Sawmills

ADA Transition Plan

Mission Rd & 321A

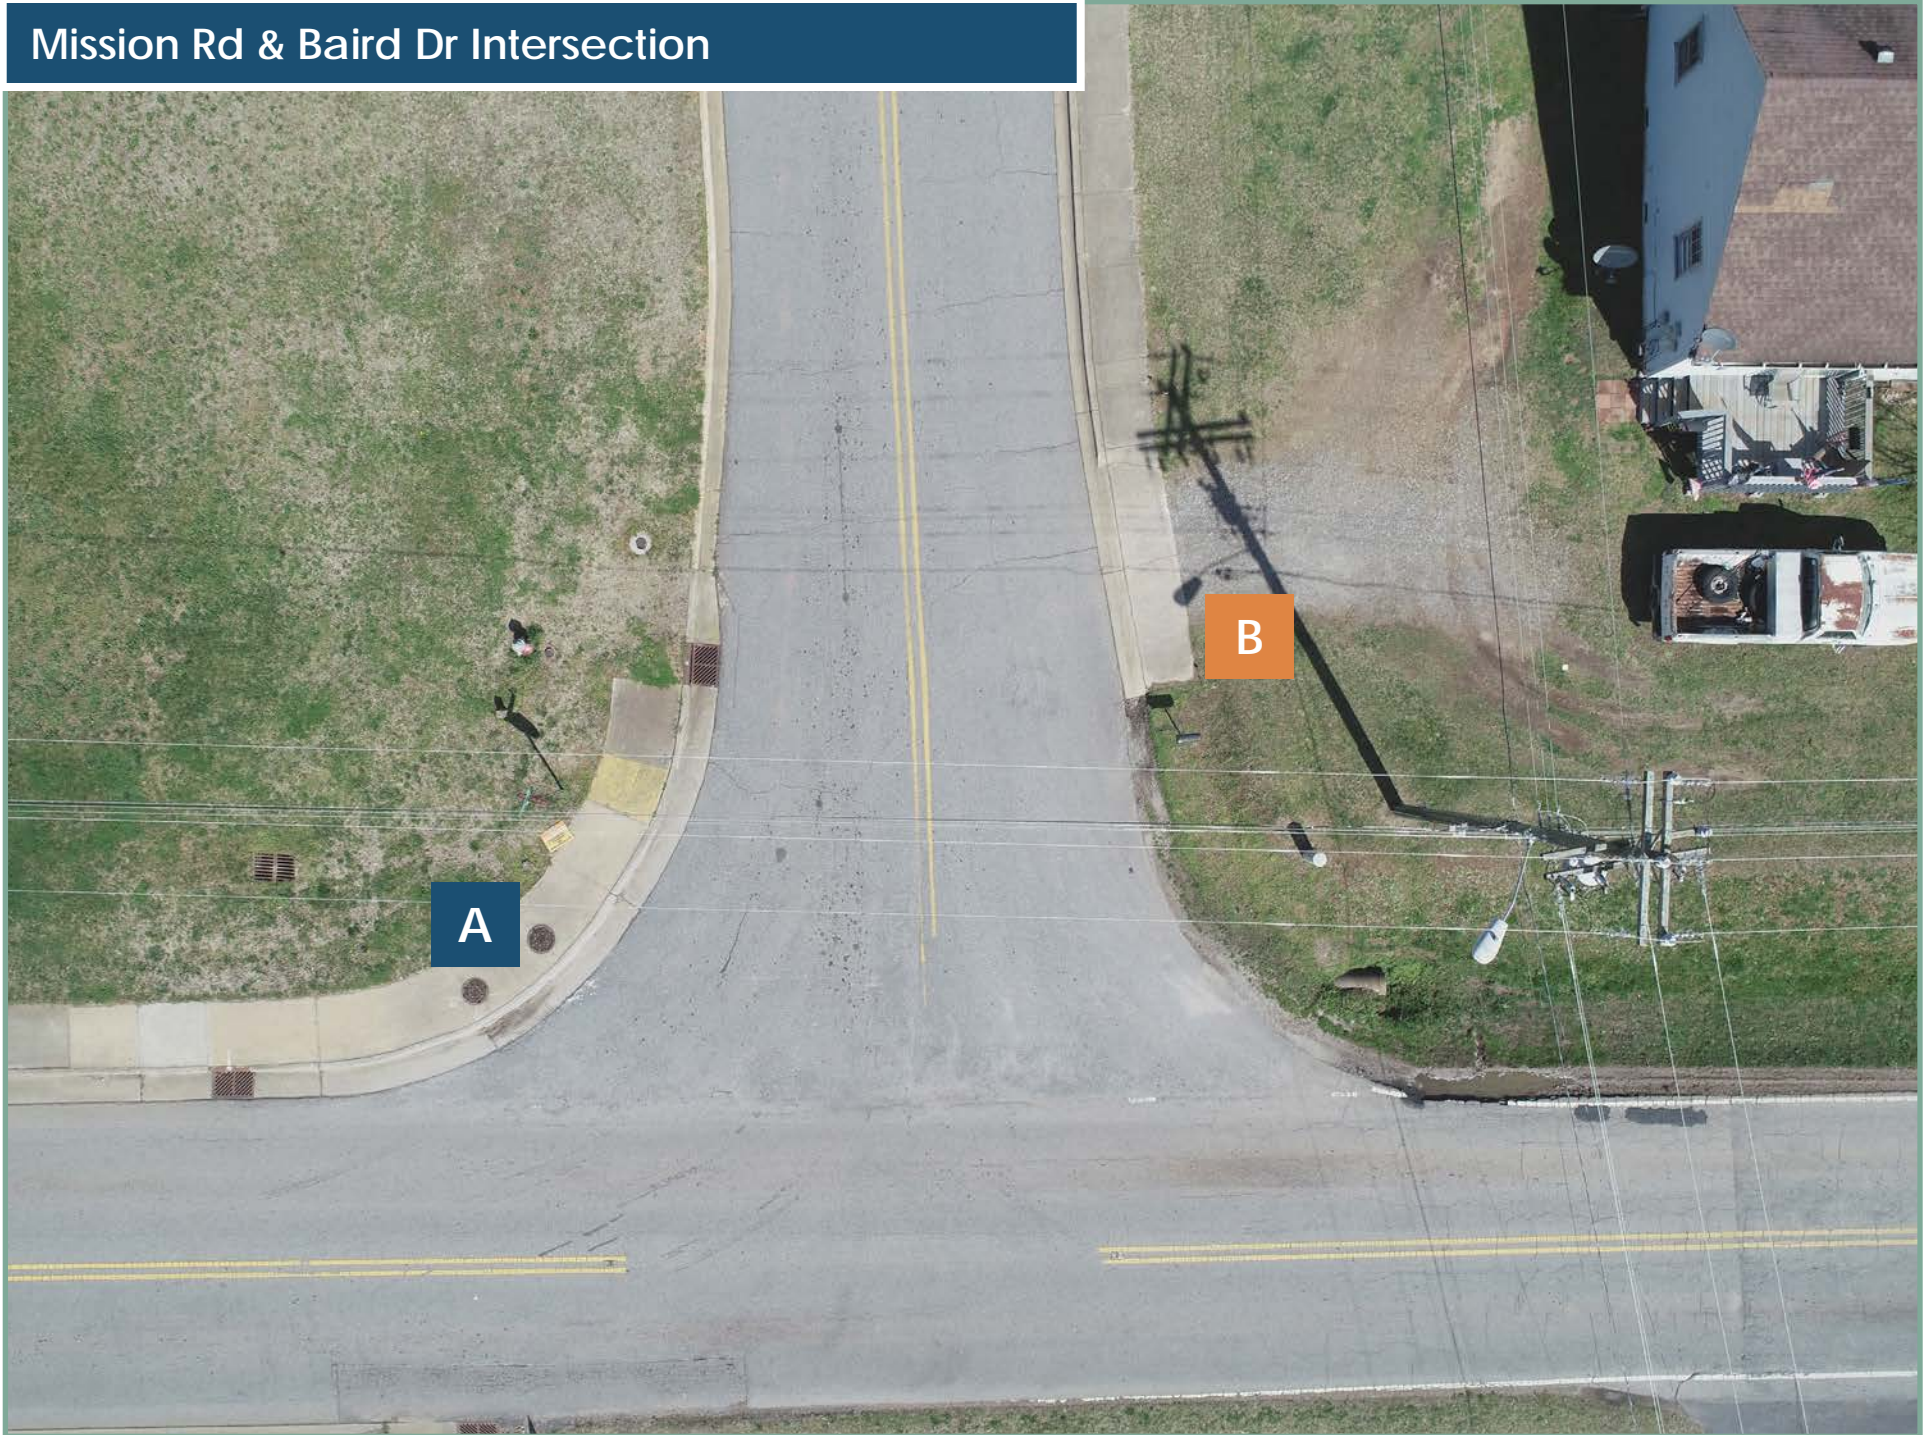
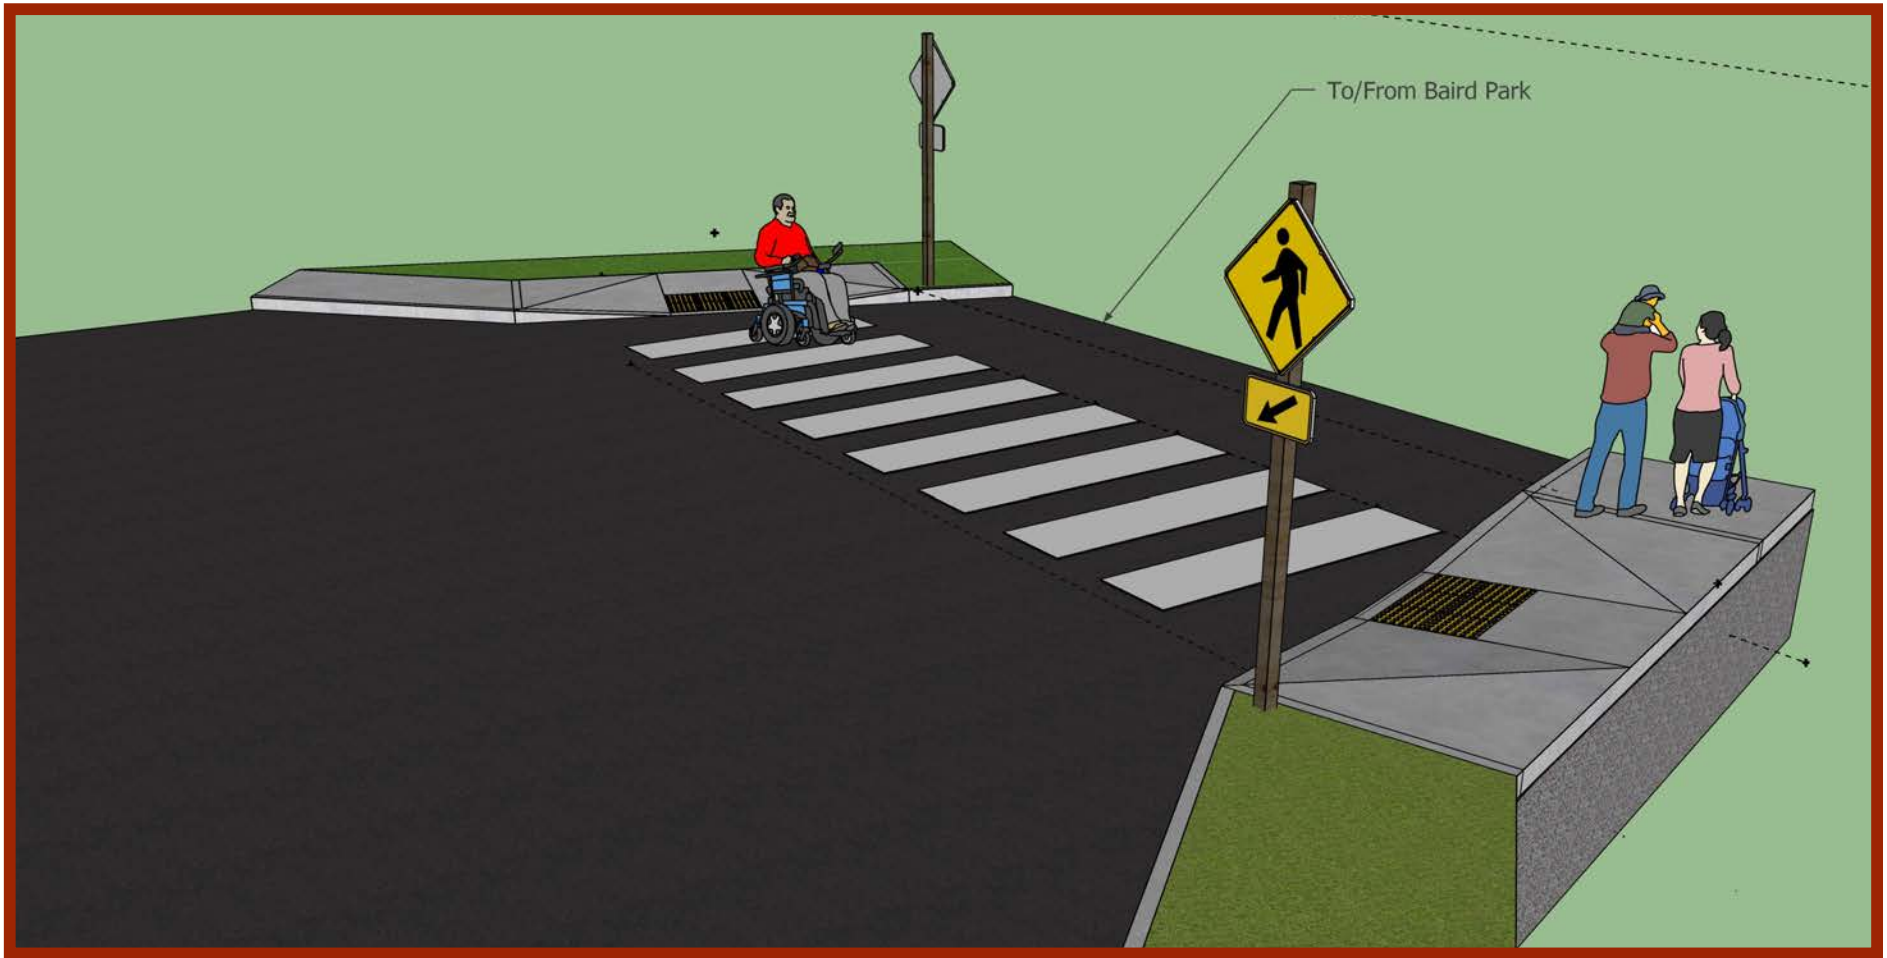
» Add detectable warnings to all curb ramps (must visually contract against pavement).

» Evaluate green times for traffic signals to ensure all pedestrians have sufficient crossing time.

» The pedestrian path must be at least 4 feet wide for the entire crossing. The surface between and on either side of the rails must be aligned with the top of the rails.

» The flangeway gap can be a maximum of 2.5 inches. Flangeway gaps can be 3 inches wide on freight rail tracks.
